# Notice of Allowability

10/685,274

SCHMIDT, ALBERT LEO

### EXAMINER'S AMENDMENT

FIG. 7

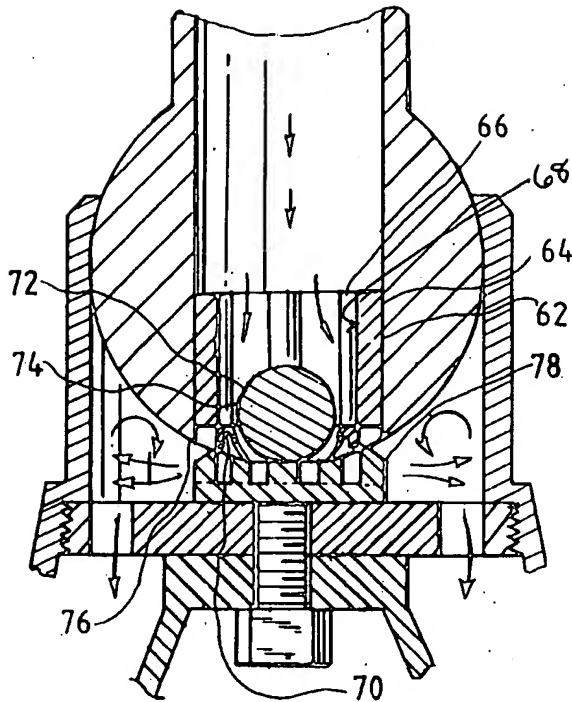
- Figures 7 and 8 must include reference number "68", which designates the inner circumferential surface of the valve body as disclosed on page 11 of the specification.

Please refer to the enclosed marked-up page 3 of 3, which indicates in red ink where reference number "68" should be located in Figures 7 and 8 of Applicant's Replacement Sheet.
